**RCRBD
Record Set
TC
06/07/2021**

CALCULATIONS ANCHORS THROUGH EXISTING WALL

PROJECT NO. - 5776
SSRA - BASE AREA IMPROVEMENTS
2305 MOUNT WERNER CIRCLE
STEAMBOAT SPRINGS, CO 80487

RE: 3-315000-1-Excavation and Support

ELEVATION VIEW - EXISTING WALL
NOT TO SCALE

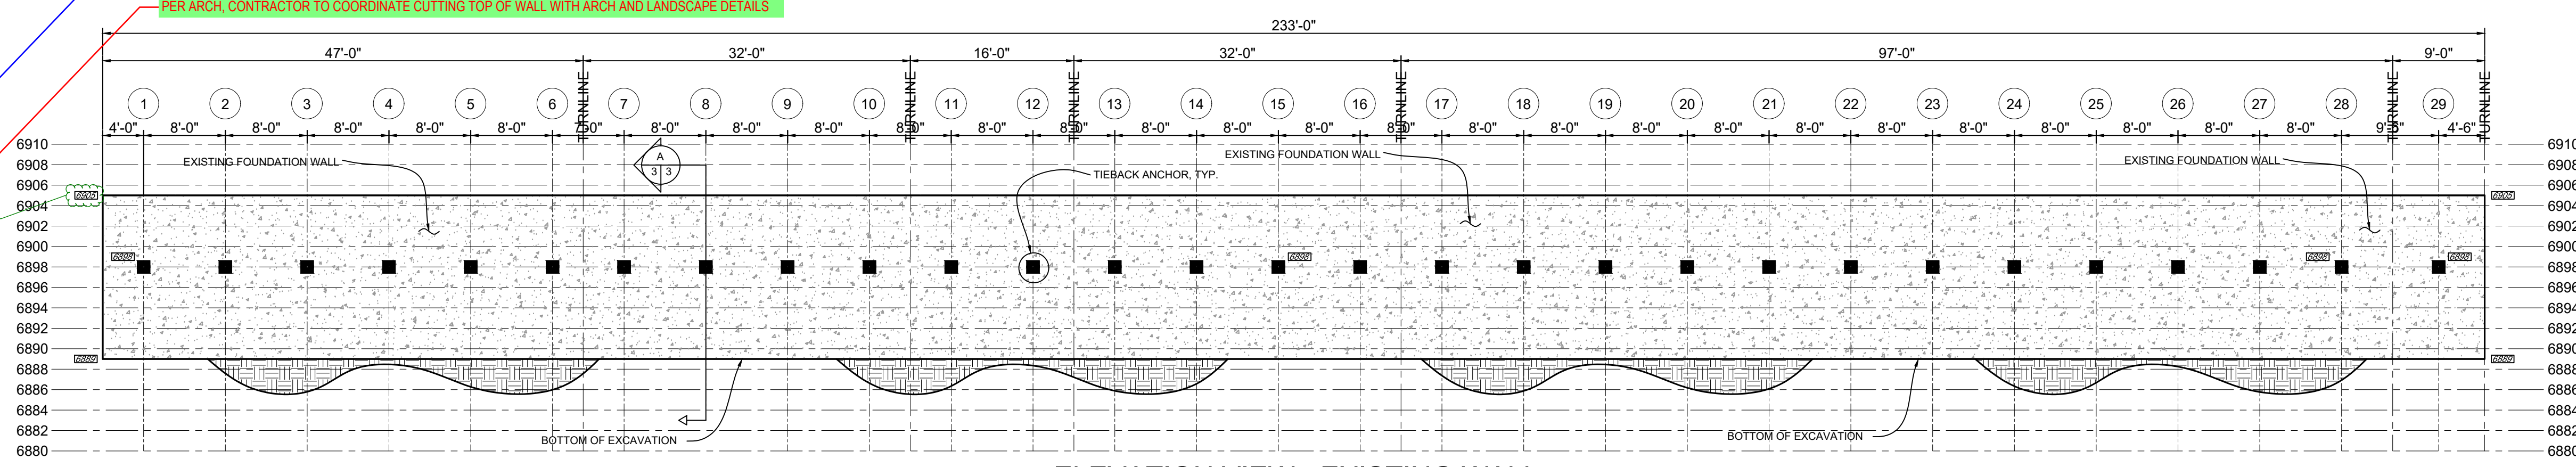
Top of structural slab at new promenade building = 6904'-8 1/4". Contractor to coordinate with arch and landscape such that remained existing walls are not in conflict with new design. (M/M)

ARCH/EOR, PLEASE CONFIRM TOP OF EXISTING WALL REMAINS UNCHANGED

PER ARCH, CONTRACTOR TO COORDINATE CUTTING TOP OF WALL WITH ARCH AND LANDSCAPE DETAILS
